## SUBJECT: 10514 LIFT ARM

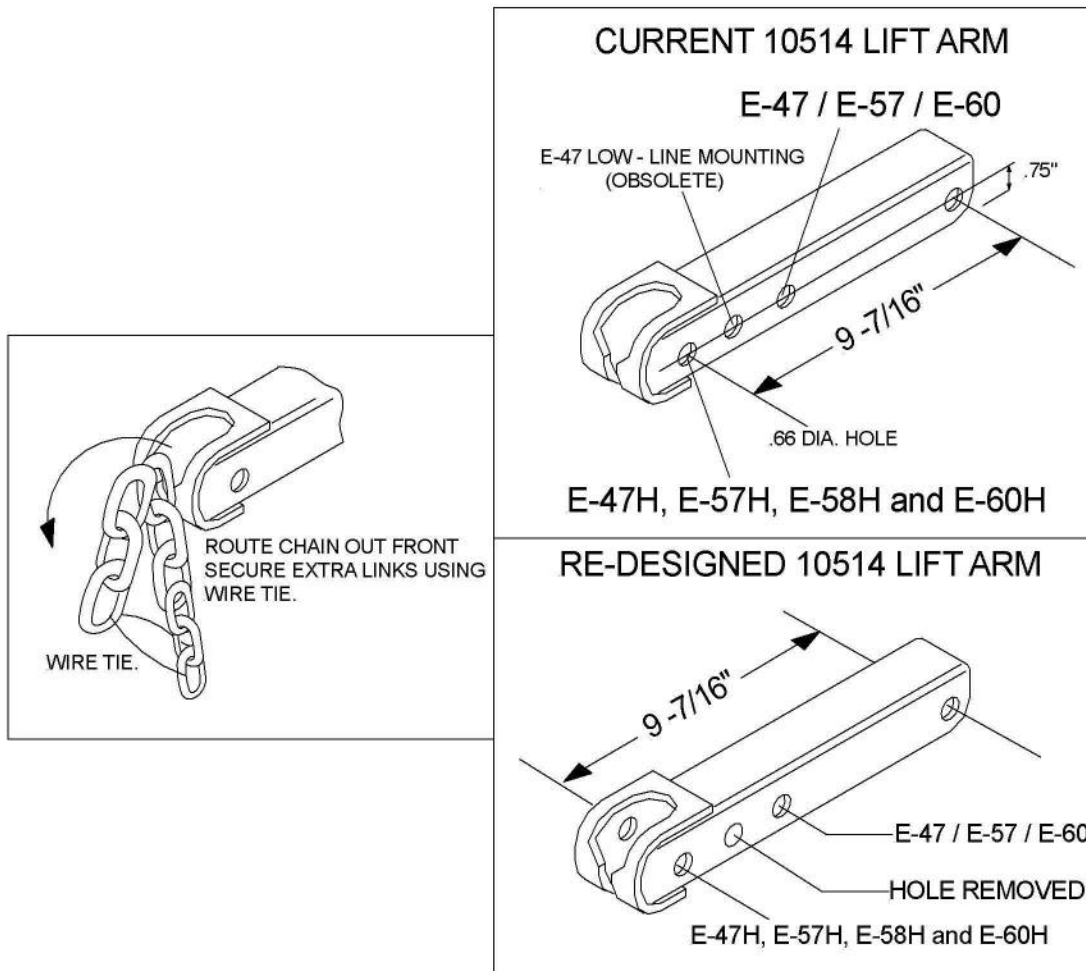
In our continued efforts to improve distributor profit margins and reduce inventory through consolidation of part numbers and improved product quality, we have made a change to our 10514 Lift Arm used on all of our EZ Custom, EZ Mount Classic Systems.

As a result, this product enhancement will standardize our Lift arm allowing all Electro-Lift® hydraulic units whether 6" or 8" stroke units to be used on all of our EZ Mount Custom, EZ Mount Classic Systems. This will be a running change and will NOT obsolete any inventory at the factory or in the field.

To modify an existing 10514 Lift Arm to be used on a EZ Mount Custom or EZ Mount Classic to accept an "H" (8" stroke) hydraulic unit another hole must be drilled in the end of the lift arm. Per illustration
